JUNCTION FLATS
4433 42ND AVENUE SW, SEATTLE, WA

DESIGN RECOMMENDATION MEETING II
DPD #3013912

JANUARY 16, 2013

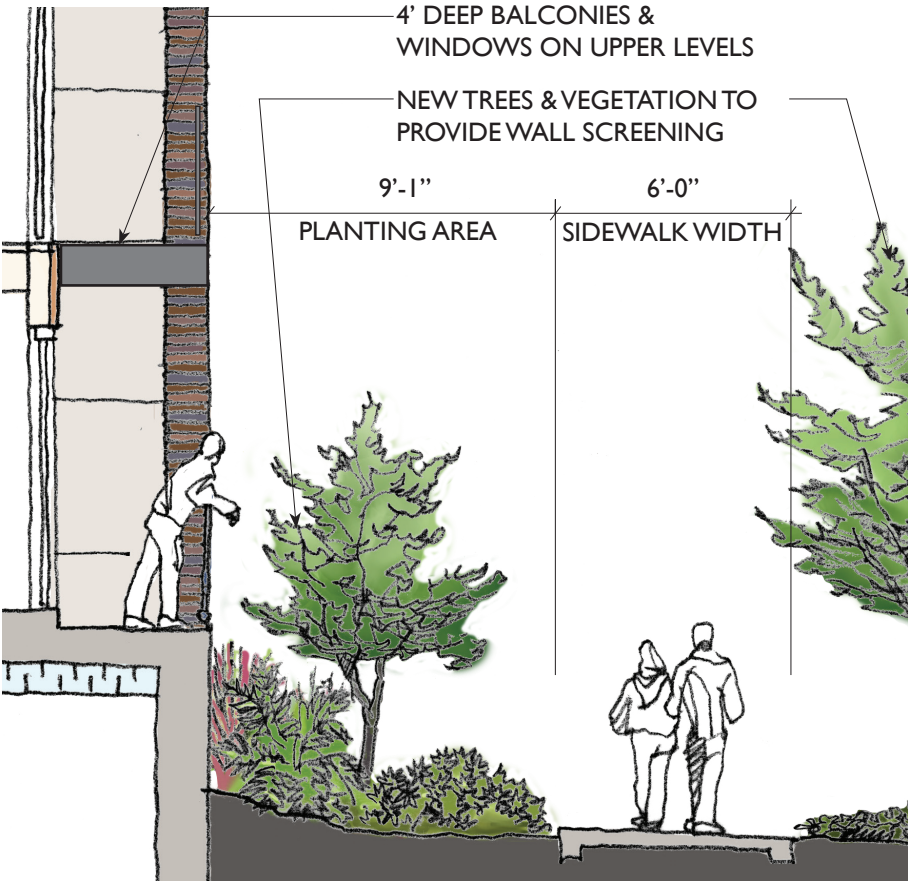
CONDITION	RESPONSE
1.The recess at the center portion of the east façade abutting three residential units should be increased from 4’ to 6’ minimum (or more) with the intent to create usable residential amenity, to encourage human activity and enliven the streetscape. (A-2,A-4)	While increasing the depth of the recess along the east façade from 4 feet to 6 feet deep does create a deeper patio area for the units at Level 1, it has the unfortunate effect of reducing usable interior space for the units above on Levels 2 through 4.The project will be part of the Seattle Homes Within Reach program, and as such, the 1-bedroom units that are located along the east façade recess are intended to be affordable workforce housing units. Increasing the façade recess will necessitate that these affordable 1-bedroom units be changed to smaller studio units. Rather than simply increasing the depth of the recess by 2 feet, a better option is to keep the plane of the wall as-is, and add 4 foot deep balconies to multiple units above. There are numerous precedents for 4 foot deep balconies all across Seattle, and these balconies will create usable residential amenity, encourage human activity, and enliven the streetscape, better meeting the intent of the Board. See the rendered elevation below.

2.Vary (lower) the roof parapet height at the center portion of the east façade to accentuate the modulation between the two mansard-roofed building masses.This variation of parapet height should also be applied in a similar fashion at the north, west and south facades (A-2,A-4)	The parapet heights along the east facade have been revised to further accentuate the separate building volumes and increase vertical modulation along that facade. See the rendered elevation below.

3. Utilize the arrangement of balconies (Juliette), sliding glass doors and window detailing/framing to provide variety on the east and west façades. Building facades comprised of exclusively Juliette balconies is strongly discouraged. (A-2,A-4)	The revised preferred proposal includes a balanced mix of standalone windows, windows with Juliette balconies, and 4 foot deep balconies along the east facade. See the rendered elevation below.

OPTION I (PREFERRED): MAINTAIN 4’ BUILDING RECESS & ADD 4’ DEEP BALCONIES TO LEVELS 2-4

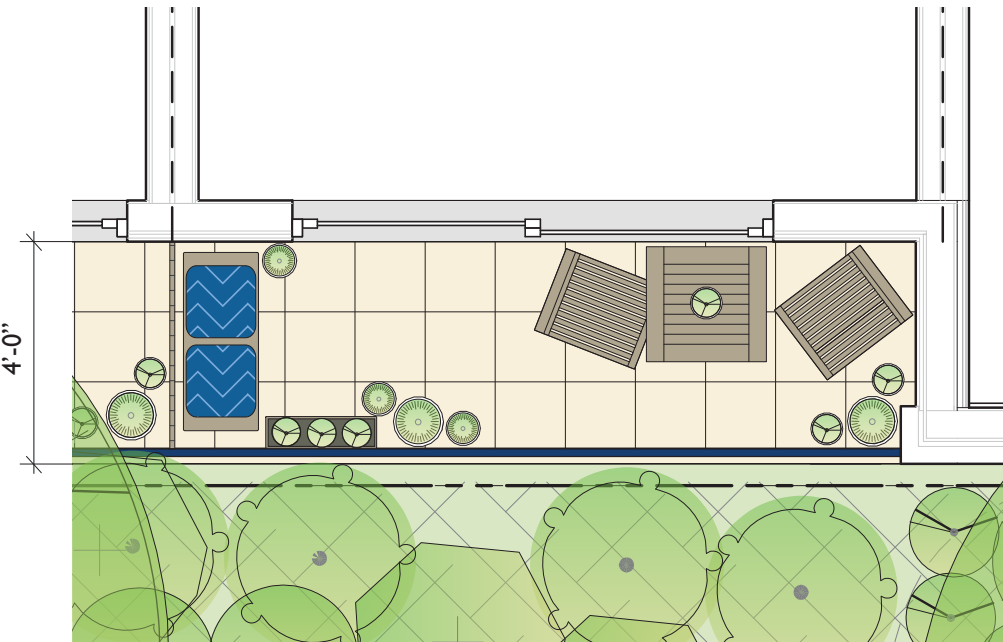
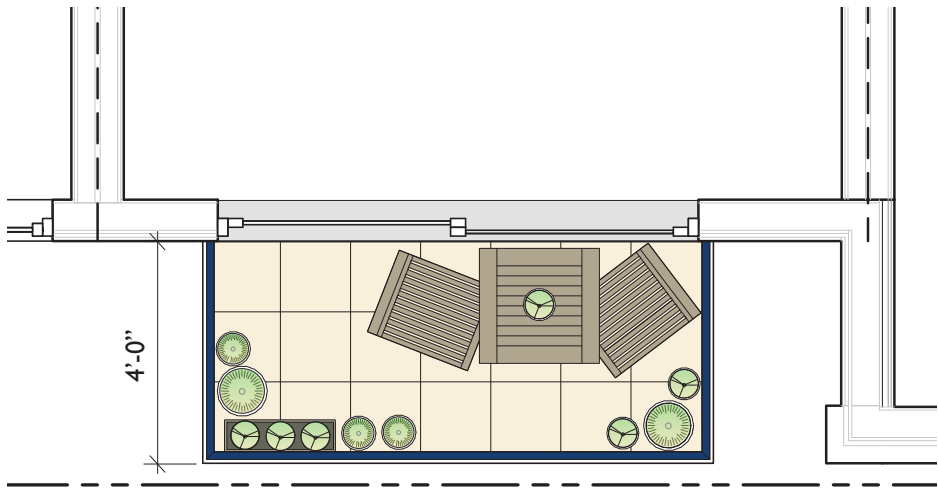
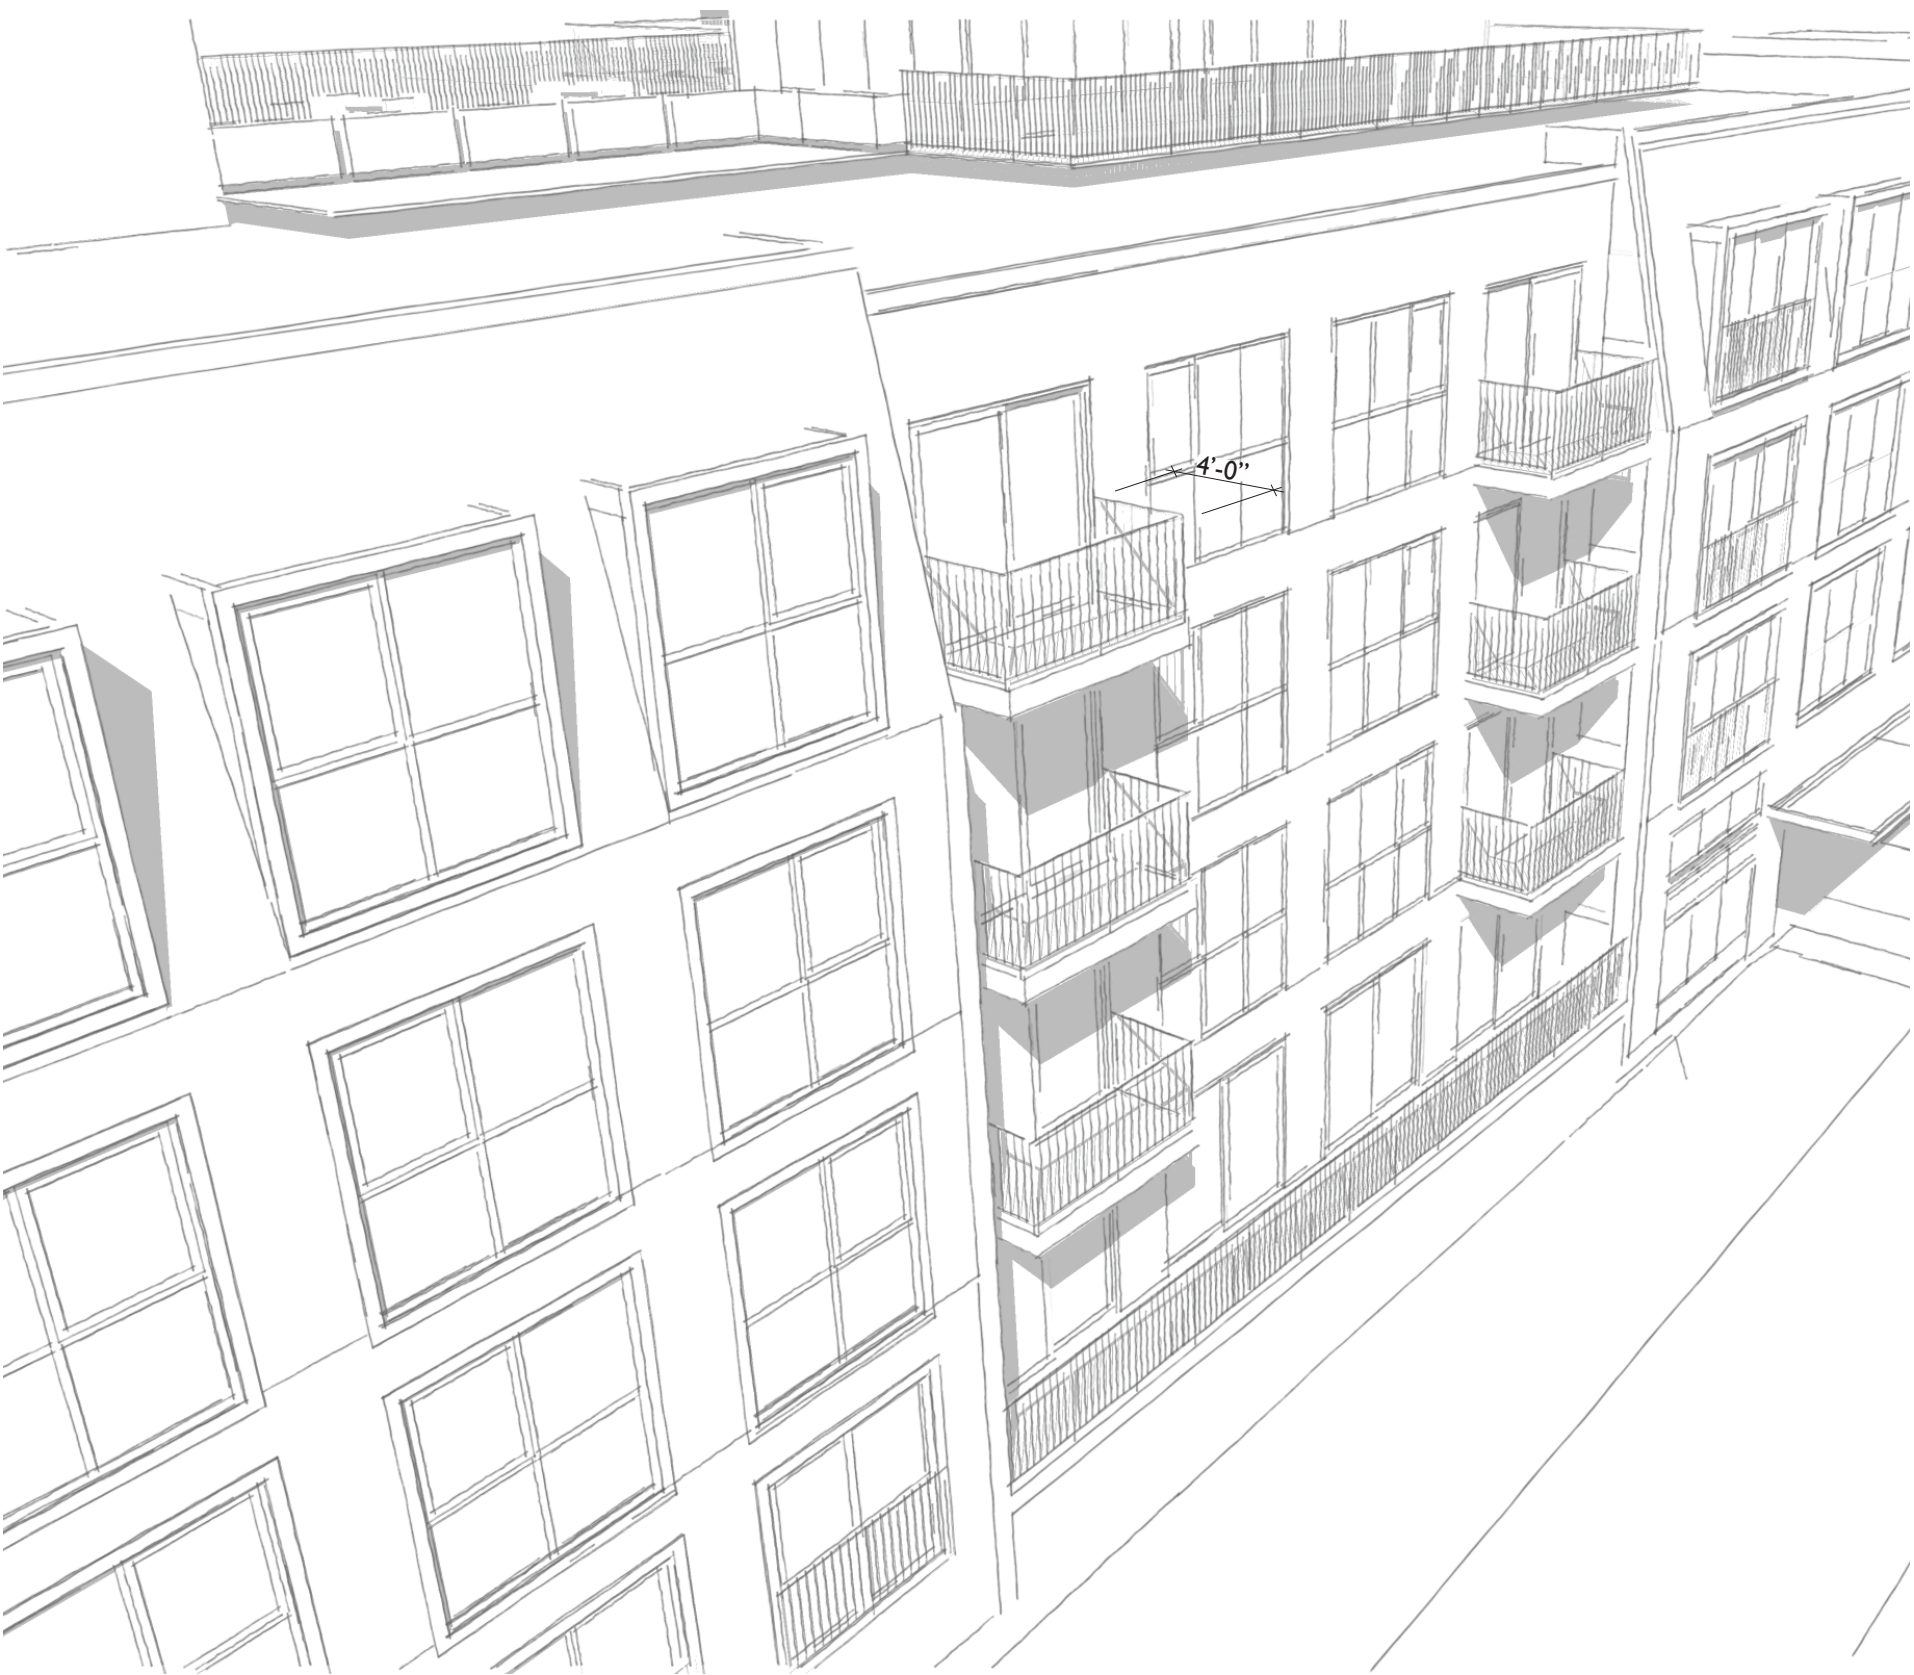
- Significant increase in diversity of window/door types compared to originally proposed design, creating an active and interesting experience from the sidewalk, per guidelines A-4 Human Activity and C-2 Architectural Concept and Consistency.

- The 4 foot deep balconies provide adequate room for a cafe table or bench, promoting and encouraging activity along the street, per guidelines A-2 Streetscape Compatibility, A-4 Human Activity, A-7 Residential Open Space, and C-3 Human Scale; both project precedents and references in the SMC support 4 feet as a valid balcony depth.

- The Board’s intent to the intent to create usable residential amenity, encourage human activity, and enliven the streetscape, per guidelines A-2 Streetscape Compatibility and A-4 Human Activity, is best met through adding an additional six balconies above the Level 1 patio.

- By adding exterior balconies in lieu of a full façade setback, there is no reduction in the livable interior area of the units, and usable residential amenity space is added to an additional six units, per guideline A-7 Residential Open Space.

- Usable interior space is maintained in the twelve affordable 1-bedroom workforce housing units that are located at the east façade recess.
